**DEPARTMENT OF PUBLIC WORKS
MADISON, WISCONSIN**

Contract Name CCB/MMB Tenant Improvement Remodels - Phase 2

Change Order Description Miscellaneous Change Requests

Date	7/8/08
Change Order Number	CO 9
To Public Works Contract Number	6080
Original Contract Project Number	0
Change Order Project Number	0

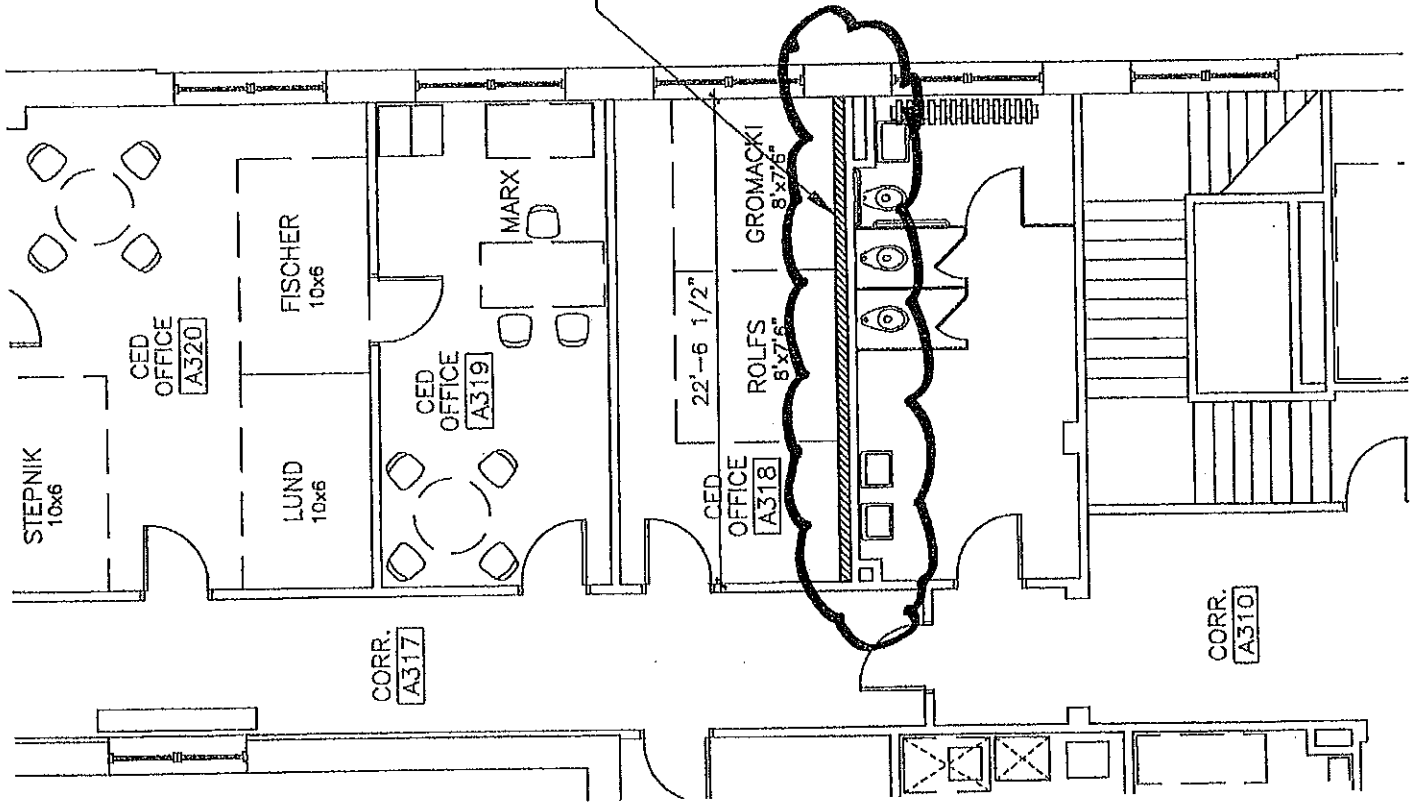
MMB: install sound wall at CED Office 318 per attached. Remove and reinstall wood base.

INSTALL GYP. BD. SOUND WALL
ON FURRING OVER EXISTING BLOCK WALL,
REMOVE AND REPLACE POWER OUTLETS (4),
REMOVE AND REPLACE SPECIAL WOOD BASEBOARDS,
SMOOTH FINISH & PAINT

ADD DATA OUTLETS AT MMB 1ST FLOOR
TE TRAFFIC ENGINEERING

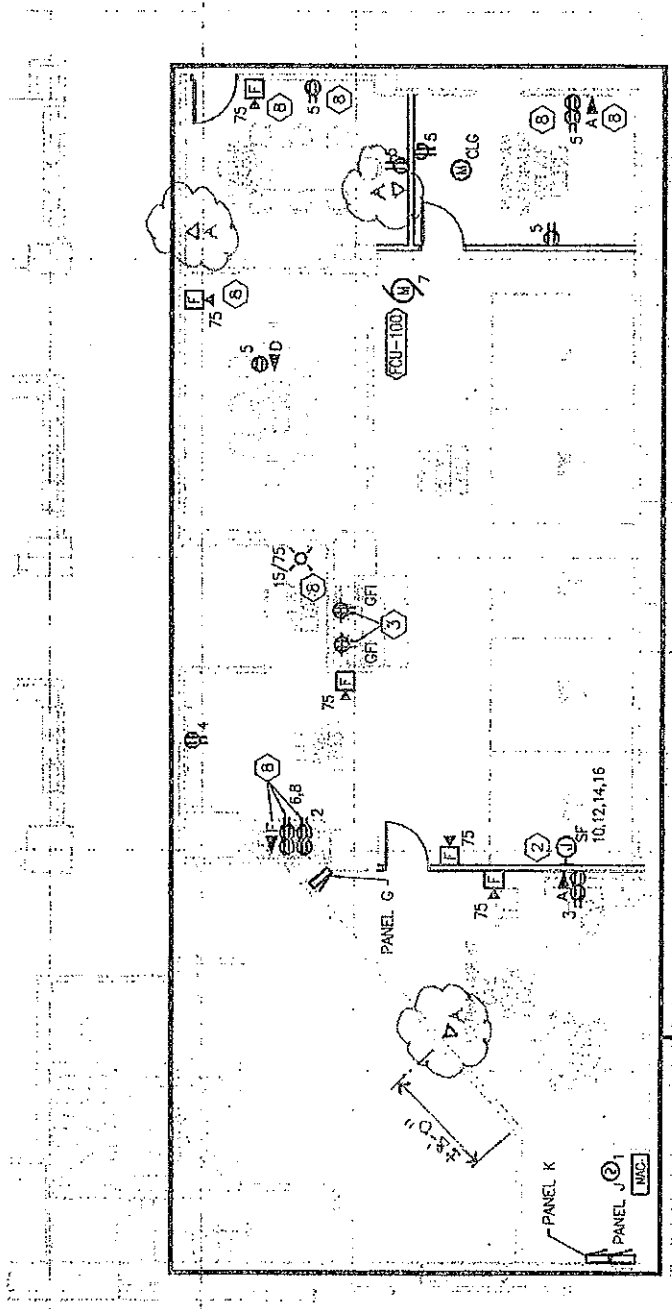
MMB - Add 3 data outlets in Traffic Engineering per attached sketch.

Add 3 DATA outlets in Traffic Engineering, 2-CAT6 cables per outlet.

- Hearing Room 111:
Add two(2) data outlets, each with 2-SIO.
- CTE Office 109:
Add one(1) data outlet, with 2-SIO.

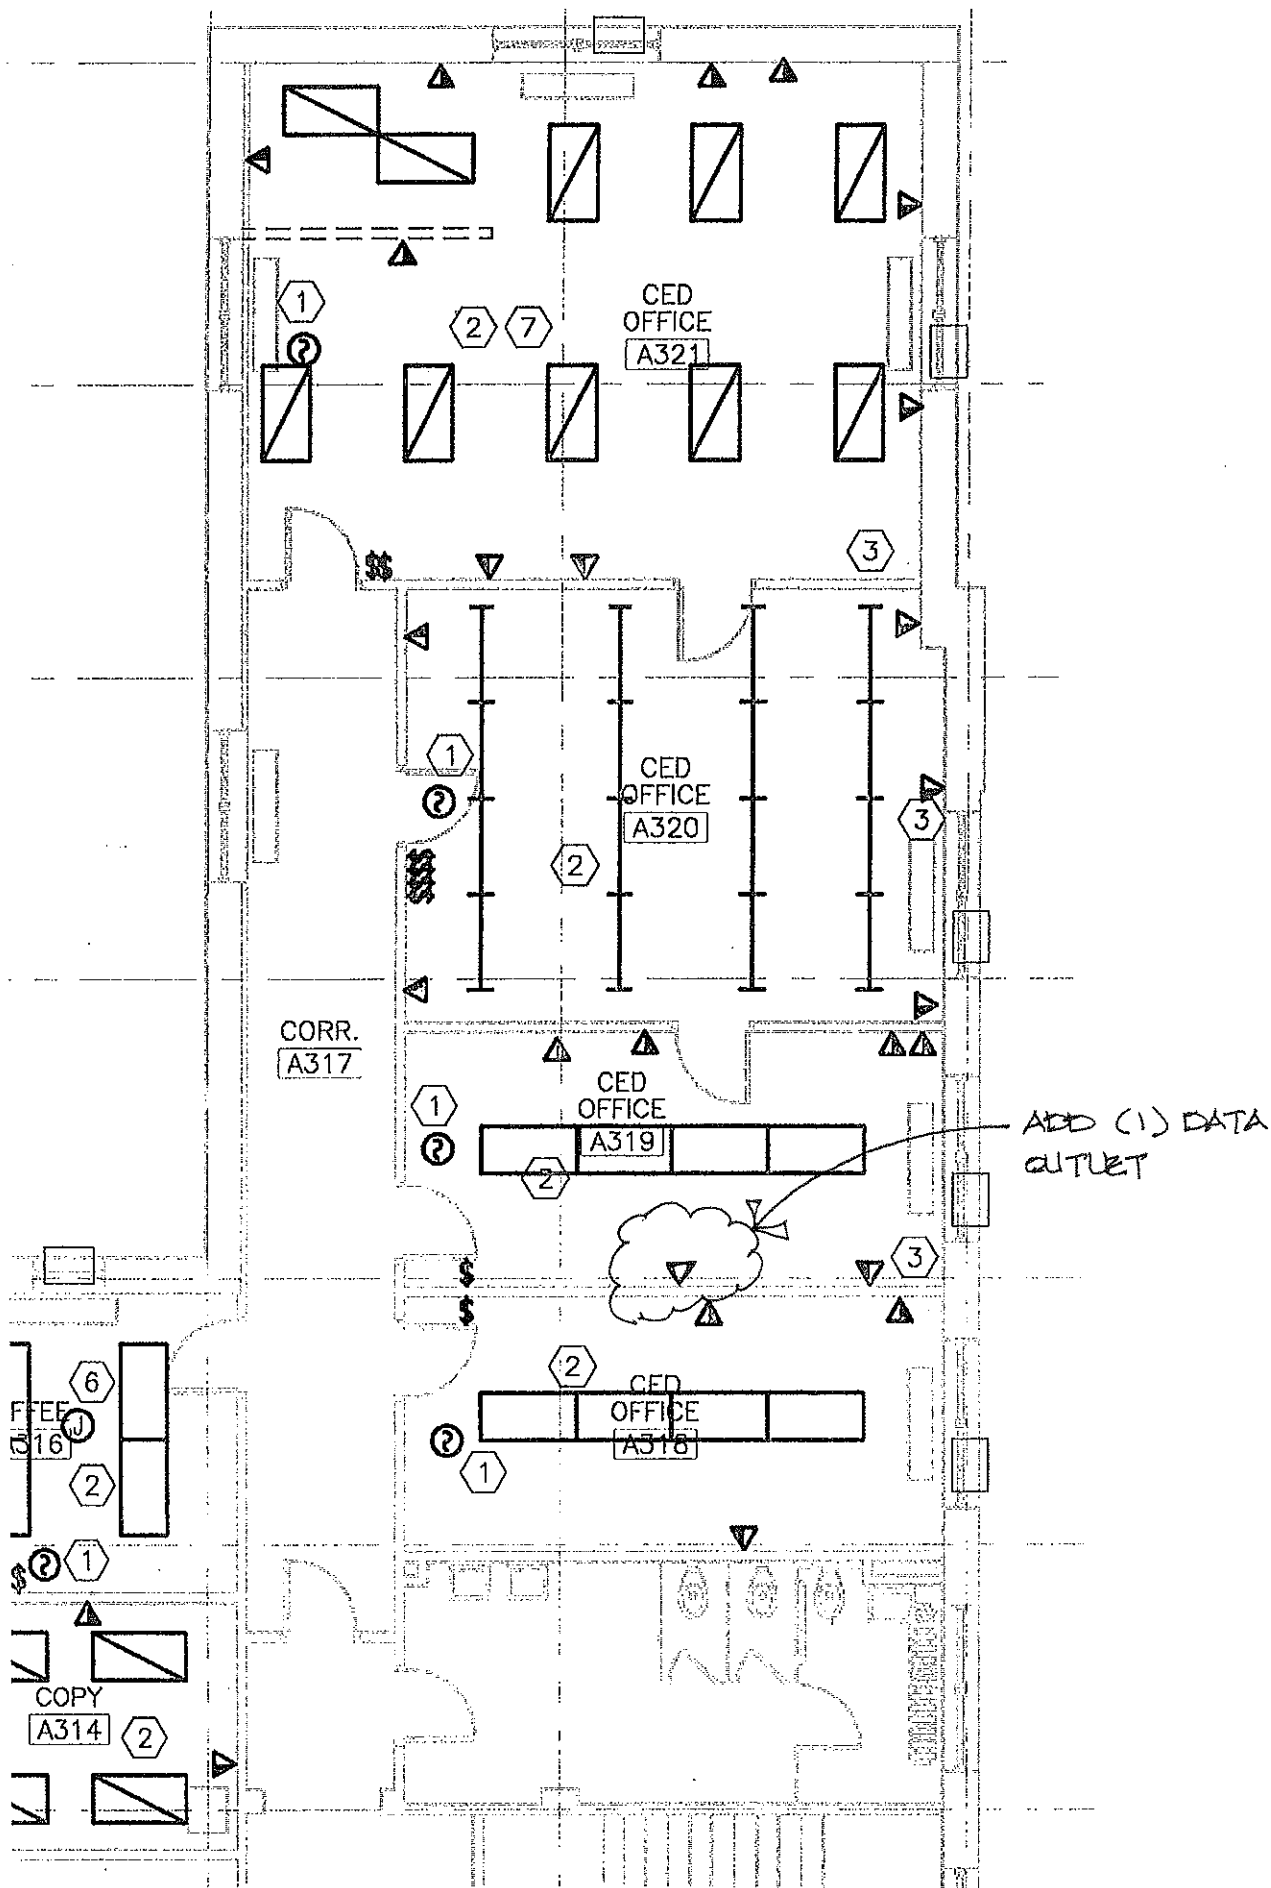
RFI #21 - Provide a S10 at Room A319.

**Add 1-"A" SIO in RM A319 on 3rd floor of MMB.
\$190.00 per CAT6 plus \$75.00 for extra labor to drill into attic.**

Boston crown molding - H21R	2"H x 2-3/8"P x 3-1/16"F x 6'6"L	your price: \$ 32.00	1	add to cart
Boston flexible molding - H21RFL	2"H x 2-3/8"P x 3-1/16"F x 6'6"L	your price: \$ 64.00	1	add to cart

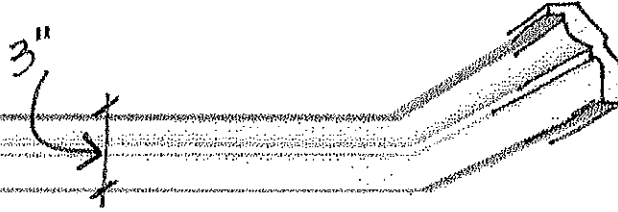
PR 04: Add crown molding. Approx. 220 l.f. per attached profile, only on walls that had ceilings going through and wall under ceilings. To be painted same color as walls and ceilings.

* SOMETHING
SIMILAR TO
THIS - TRY TO
MATCH WHAT'S
OUT IN THE CORRIDORS (PROFILE)

- ROOMS:
- A302 DIRECTOR CONF.
 - A303 DIRECTOR OFFICE
 - A305 CEO OFFICE
 - A306 VESTIBLE
 - A307 CEO OFFICE
